**Atari Technical Bulletin**  
**Number: TT30-0001**  
**Date: December 12, 1991**  
**Page 1 of 5**

Product(s) Affected: TT030, (MEGA STE)  
Model: TT030/2/4/8, MEGA STE/1/2/4  
Type of ATB: As Needed  
ECO #: N/A

**Reason for ATB:**

Figure 1

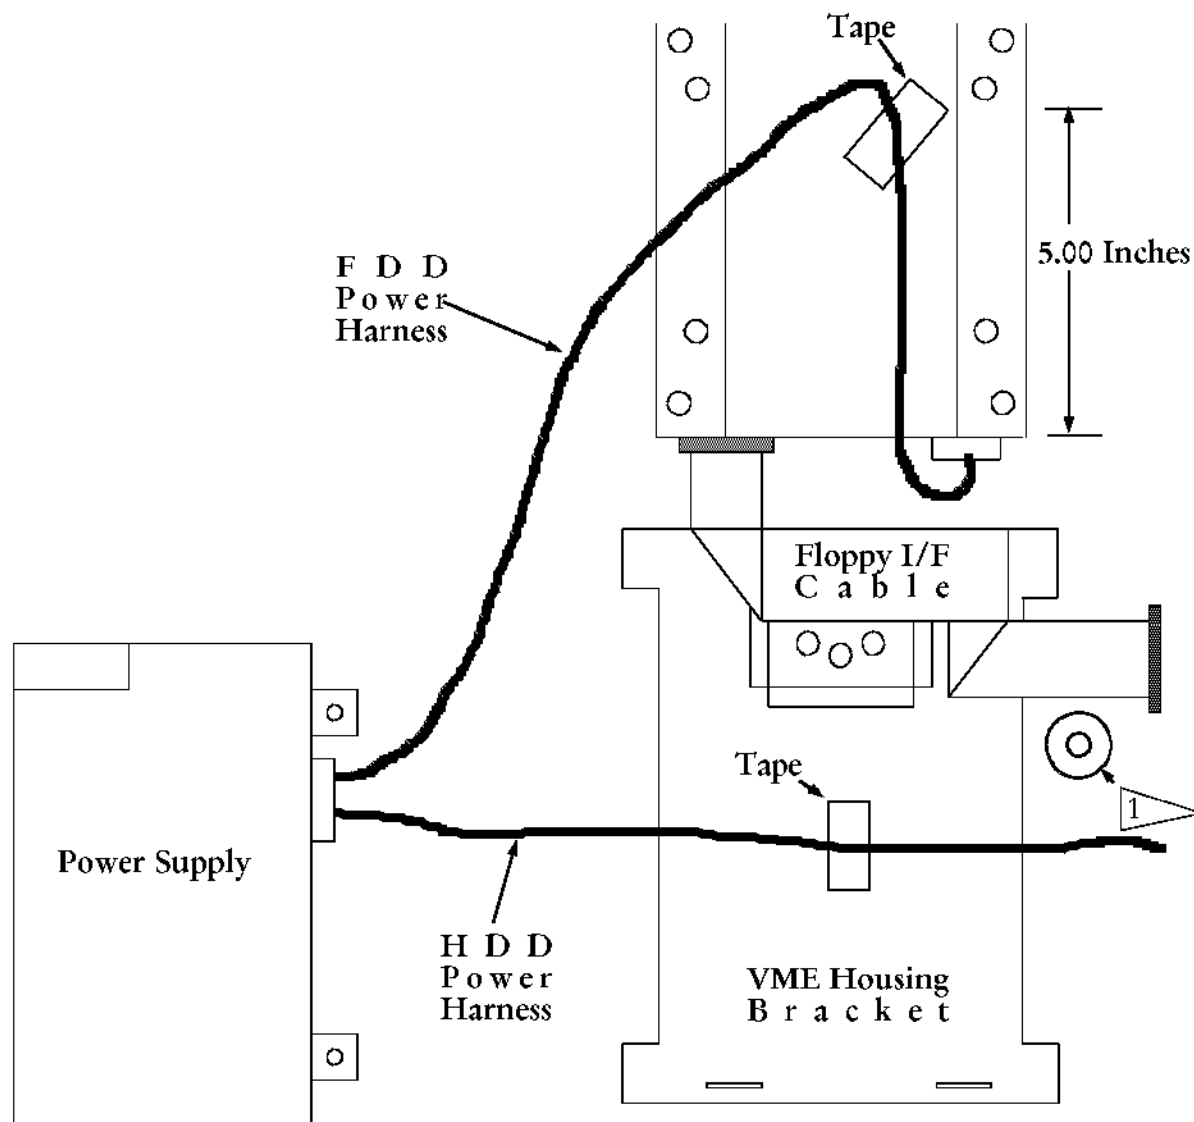
- 2.) Lift off the top case and set it behind the bottom case. Check to make sure the Floppy Drive is mounted to the Mounting Bracket as shown in Figure 1. If it is not, remove the screws holding the bracket to the plastic case. Remove the four screws holding the Drive to the bracket. Re-assemble the drive onto the bracket as in Figure 1. Mount the bracket with the attached drive to the plastic case of the computer.

NOTE: Mounting Bracket offset MUST BE away from the drive as shown above!
